DRAFT VARIATION TO THE TERRITORY PLAN No. 345 MAWSON
GROUP CENTRE: ZONE CHANGES AND AMENDMENTS TO THE
MAWSON PRECINCT MAP AND CODE

STANDING COMMITTEE ON PLANNING AND URBAN RENEWAL

REPORT 6

Figure 2: PROPOSED MAWSON TERRITORY PLAN MAP

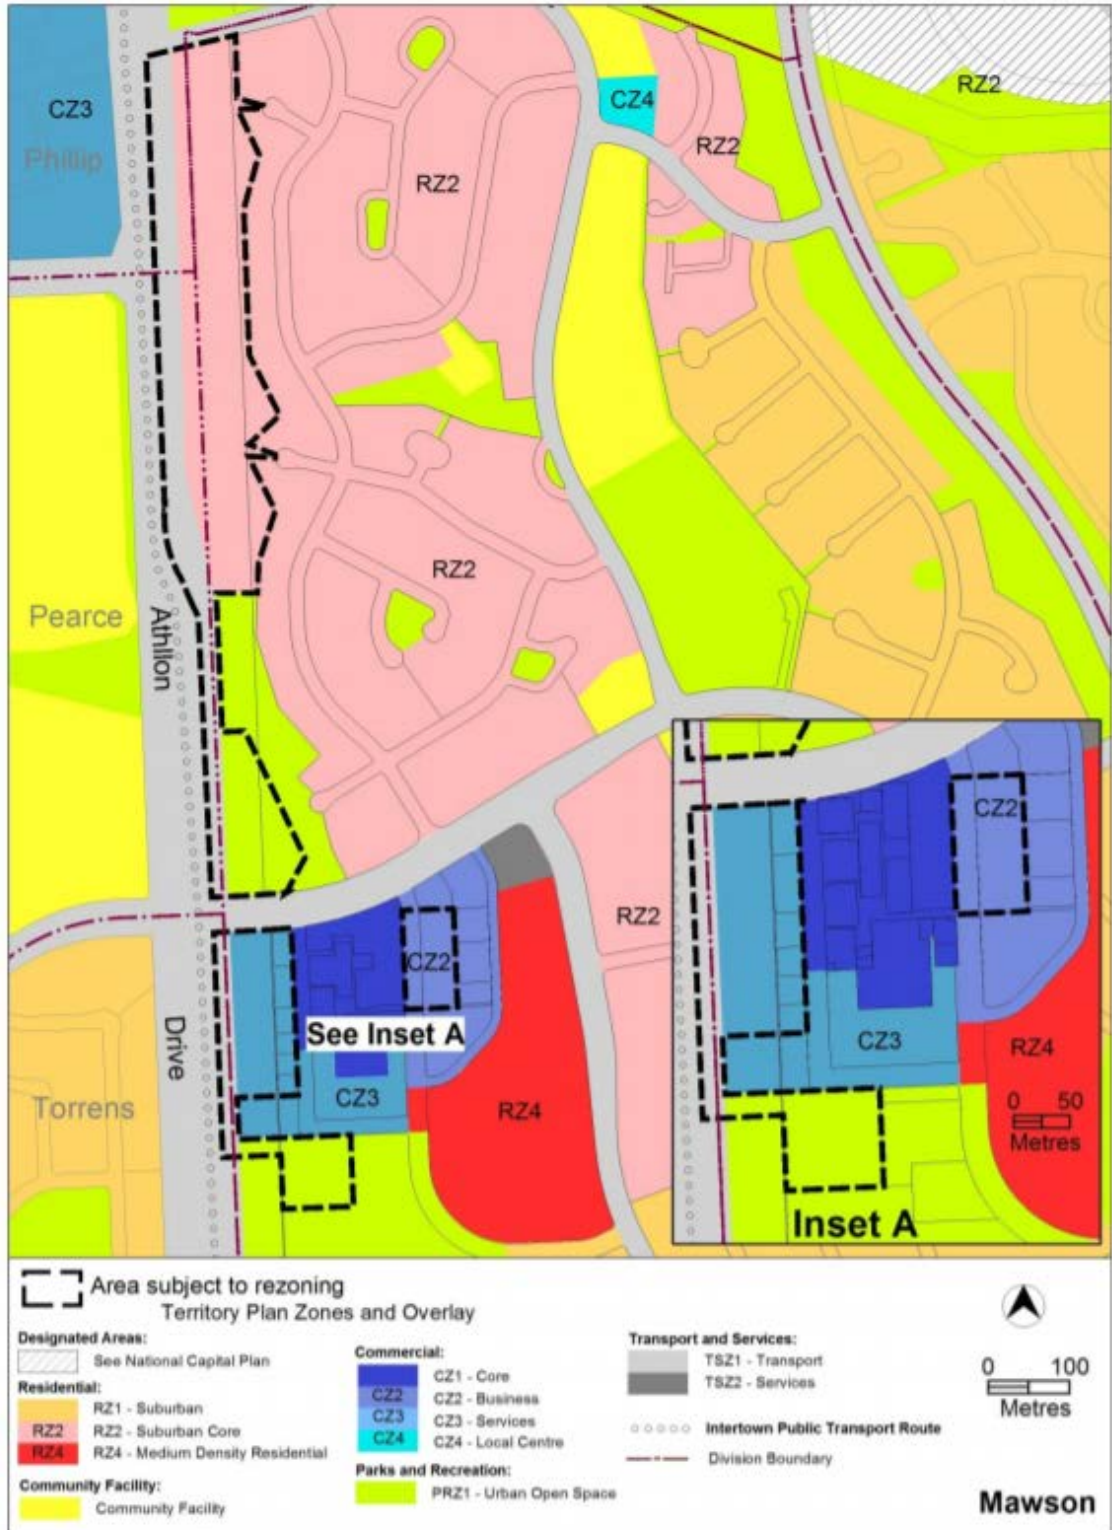
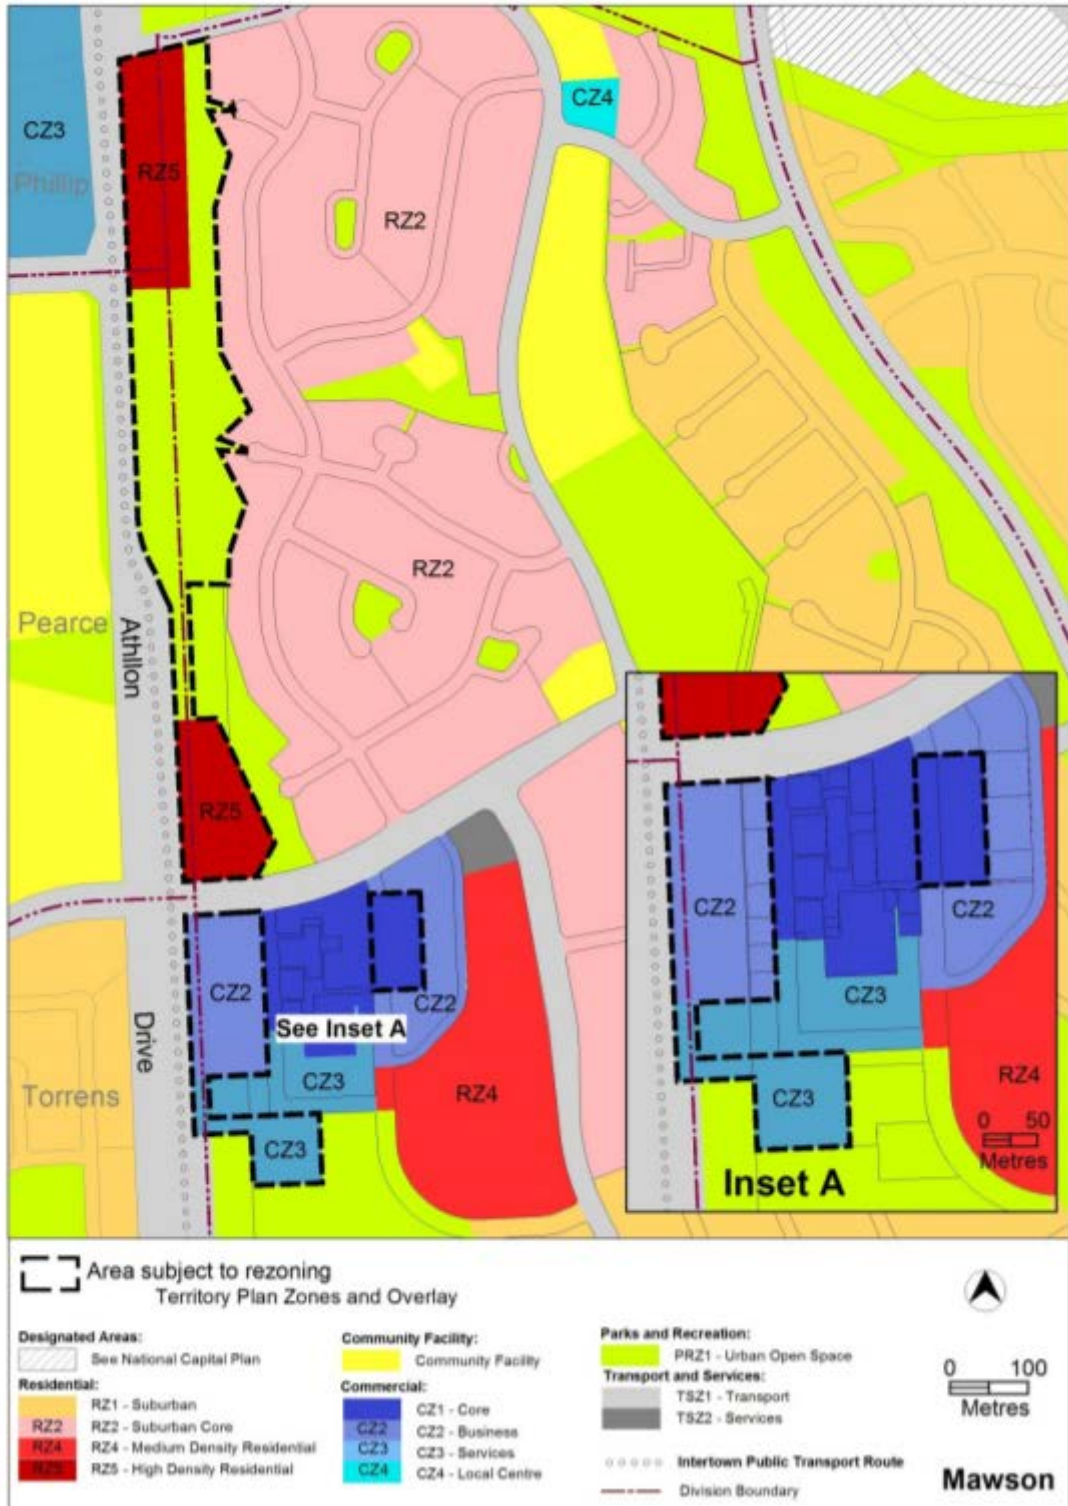
3.10 As illustrated in Figure 1 and Figure 2 the Mawson Draft Variation would make changes to the existing Territory Plan Map, including:

Figure 5: MAWSON GROUP CENTRE BUILDING HEIGHTS⁶⁶

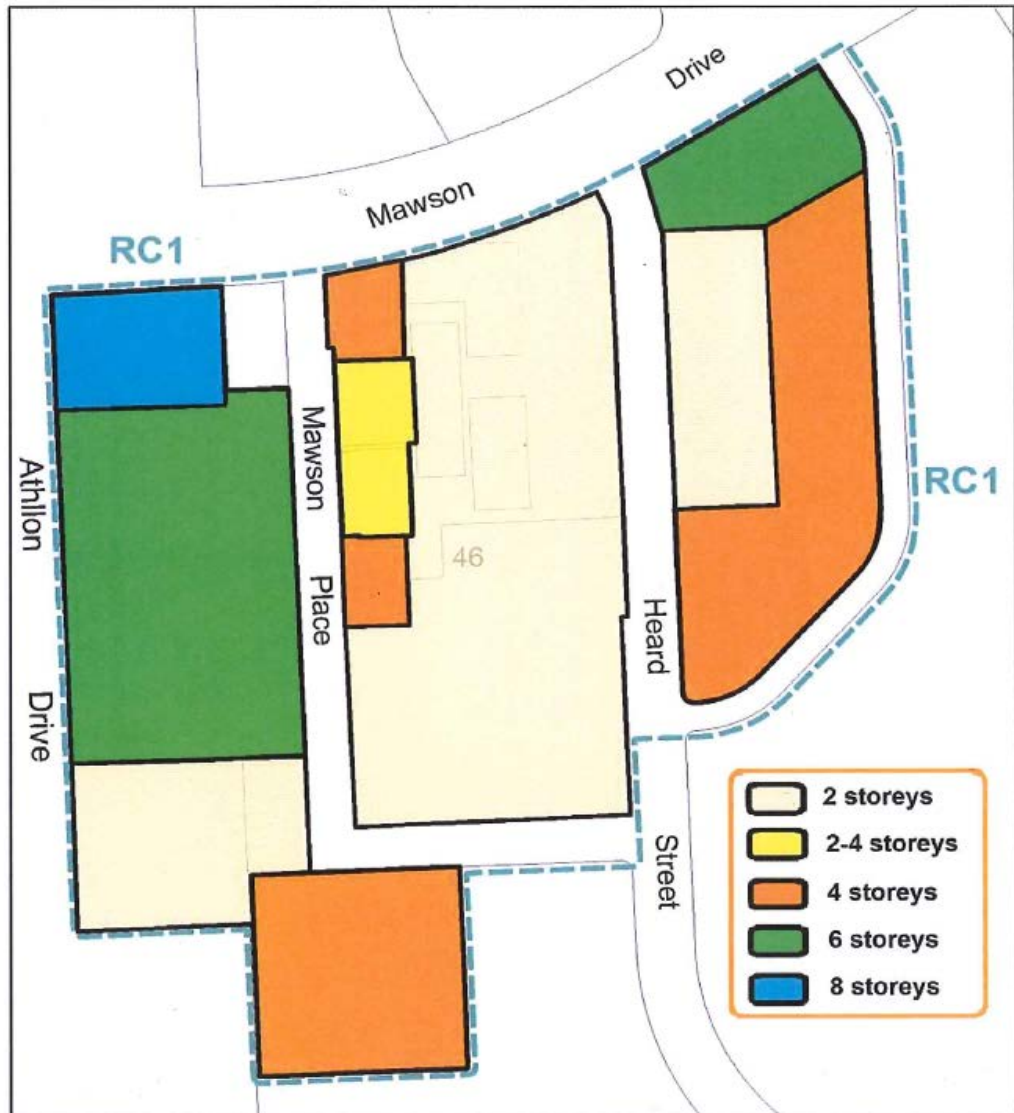
- 5.1 The Mawson Group Centre precinct code does not currently prescribe maximum building heights which means that the default building height for each zone applies. The Mawson Draft Variation would introduce maximum building heights in accordance with those illustrated in Figure 5.

- 5.16 It was acknowledged by the Directorate that the height maximums for buildings surrounding the courtyard square had been amended from what was in the Master Plan due to community feedback:

In terms of the town square itself, importantly, the master plan provided for four storeys but, in response to what we are hearing through the community engagement activities, that has been reduced to two storeys, essentially what is already there.⁶⁵

- 5.35 The Committee also noted that the shadow diagrams show that the current wording of C8 would allow the almost complete removal of mid-afternoon winter sunshine in the courtyard.
